Appl. No. 10/042,748 Amdt. dated August 11, 2003 Reply to Office action of May 9, 2003

Amendments to the Drawings:

REPLACEMENT SHEET

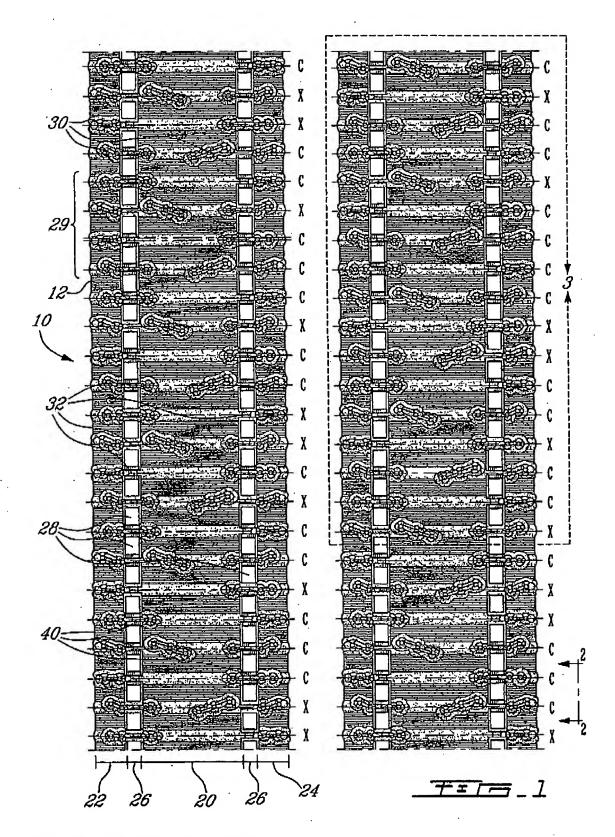
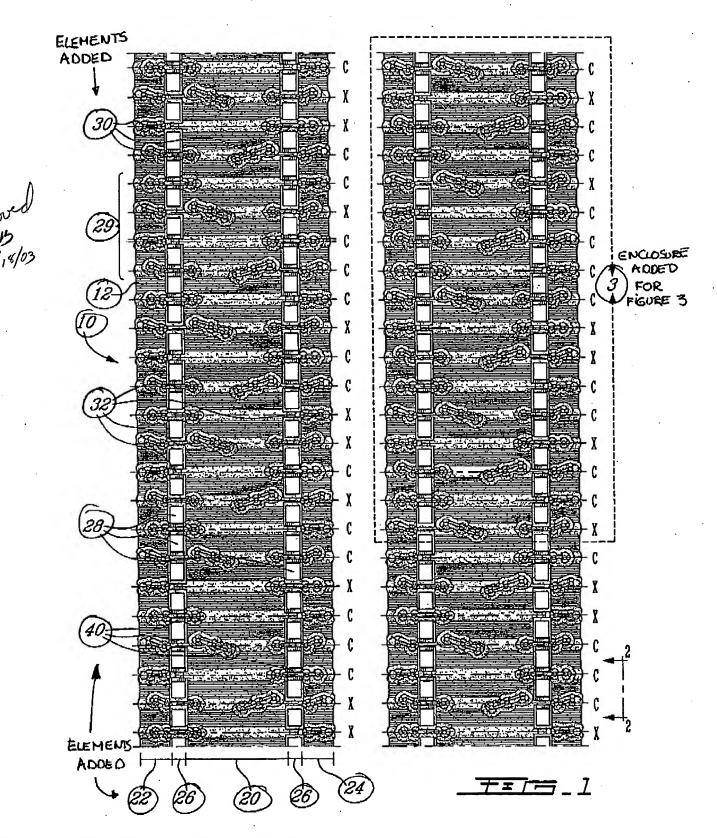
Figure 1 and 2 mainly incorporate corrections to drawing informalities by including the reference signs (10, 12, 20, 22, 24, 26, 28, 30, 32 and 40) mentioned in the description which were previously omitted on the drawings. Also, new reference signs were added (stiffeners (14), L-shaped clip (42), flange (43), flat clip (44)) without adding new matter.

Corrections to Figure 1 and 2 were also made to delete reference signs (A, B, C, D, L and one occurrence of X) which were not mentioned in the description. Furthermore, the "C" and "X" mentioned in the specification are now correctly reproduced in the currently amended Figure 1. The expressions "X=agrafes" and the equal sign (=) near the "L" have also been deleted. Figure 2 is now located on a separate drawing sheet and has been properly labelled.

Furthermore, numbers 1-48 corresponding to each tread row of the track and numbers 1-4 corresponding to consecutive occurrences of clipping sites with a clip were deleted.

REPLACEMENT SHEET

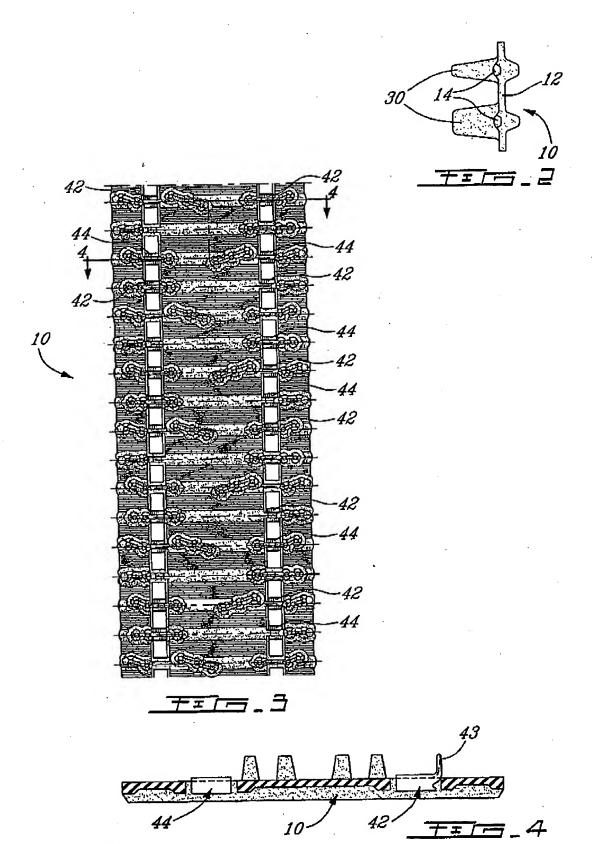
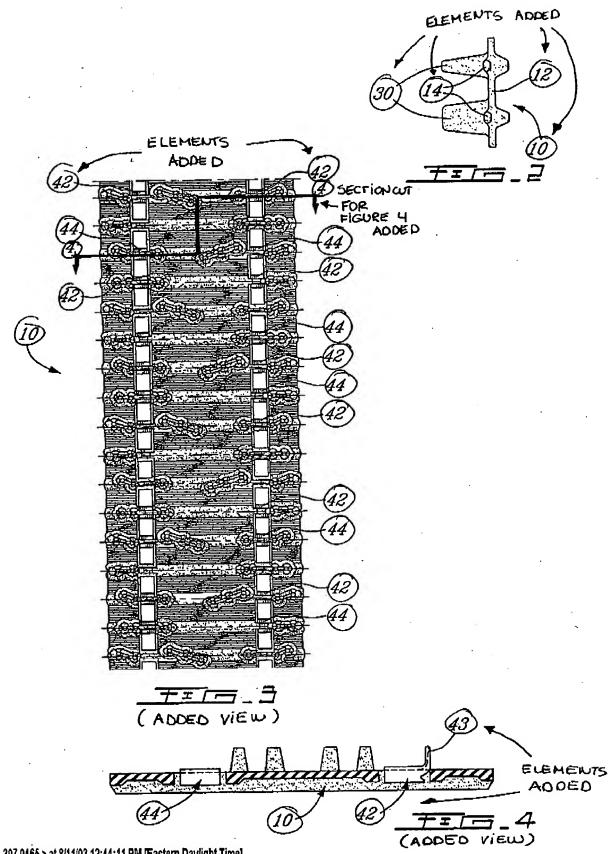
Figure 3 and 4 have been added to show the L-shaped and flat clips. No new matter has been added.
